## Alton Coal Development, LLC

Subject: **Pond 1 revision, Facility Water Plan As-built, Alton Coal Development, LLC,  
Coal Hollow Mine, Kane County, Utah, C/025/0005,**

**Title:** Pond 1 Modification

**Title:** Updated Facility Water Plan Drawing

**SEDIMENT IMPOUNDMENT POND 1 DETAILS**  
COAL HOLLOW PROJECT  
ALTON, UTAH  
**DRAWING: 5-28**

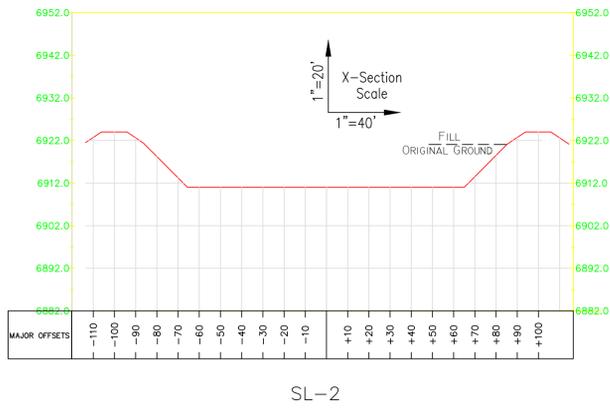
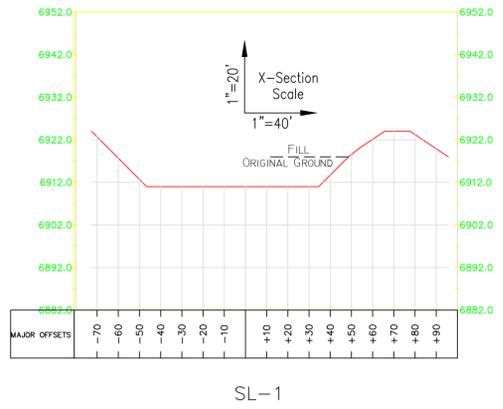
Alton Coal Development, LLC (ACD) is providing the following as per Pricilla Burton's e-mail request sent April 30, 2015. As shown in Figure 1 sediments have been removed from the Pond 1 outlet. Figures 2 and 3 show that the leaking valve has been removed. Drawing 5-28 has been submitted for review, flow into the pond has been diverted away from the pond outlet and the requested information added. Also, drawing 5-8C has been submitted for review, it depicts the as-built locations of the facility water plan.
